TRANSMITTAL LETTER

Website: www.safran-aerosystems.com**SERVICE BULLETIN****TITLE: PNR 15-40F-11 AND PNR 15-40F-80 IN-SERVICE TRIGGERING PADDLE****ATA SYSTEM: 35****1. PLANNING INFORMATION****A. Effectivity**

This Service Bulletin is issued to report field-detected failures of the triggering paddle on Portable Breathing Equipment (PBE) PNR 15-40F-11 and 15-40F-80 and to define mandatory corrective actions.

Figure 1 – Identification label for PNR 15-40F-80 with the ADOS brand

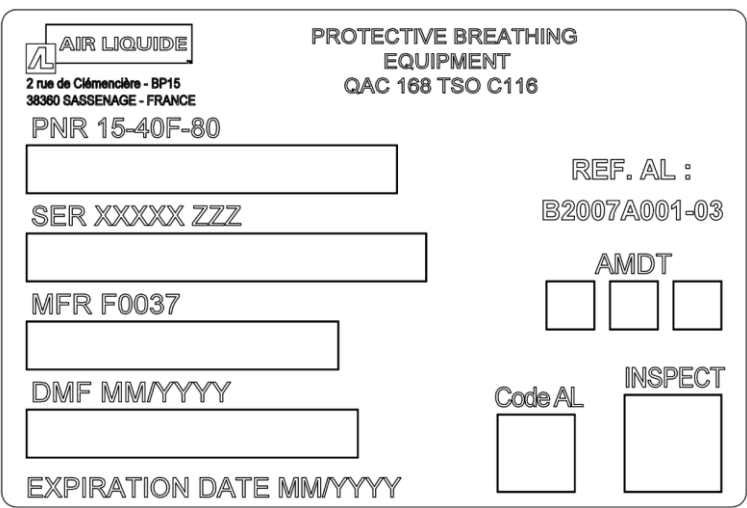
- (1) Verify PBE PNR and SER (see Figure 1, Figure 2 and Figure 3 for different label types) against Appendix A.

- (2) Remove and quarantine affected units.
- (3) Install new PBE.
